April 20, 2023

Sent via email to NeedsStudy.Comments@hq.doe.gov

Re: National Transmission Needs Study

ERCOT Transmission Improvements by In-Service Year
(\$ Billion)

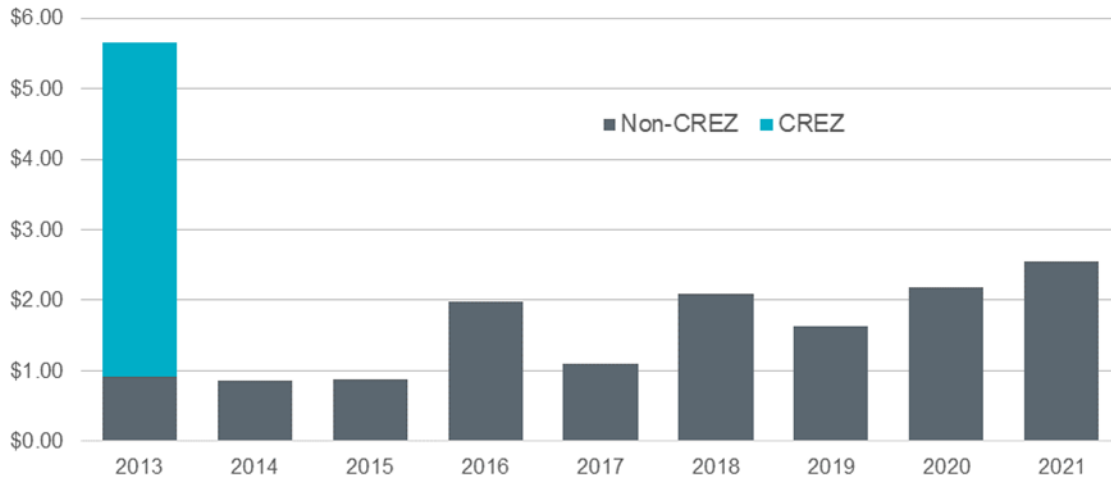
The study states that transmission investment and transmission construction in the ERCOT region have experienced a “sharp decrease” from 2016 through 2020.¹⁶ However, as noted in the report, transmission investment is “inherently lumpy,” and large investments should be considered when determining trends in transmission investment.¹⁷ In ERCOT’s case, the PUCT’s Competitive Renewable Energy Zone (CREZ) initiative, which resulted in a number of major transmission projects that connected wind-rich areas in West Texas to population centers, yielded significant new transmission investment from 2013 to 2016. When transmission investment over the past decade is considered, ERCOT has actually seen a steady increase in the transmission investment (see figure below).

Also, as shown in Table IV-1 in the study, Texas’s average Load-Weighted Circuit-Miles is the highest compared to all other regions and more than twice the regional average. ERCOT appreciates DOE’s acknowledgment on page 20 that Texas built more transmission than other regions. Study at 20. However, the report’s suggestion that transmission investment and construction has experienced a “sharp decrease” from 2016 through 2020 remains inaccurate.
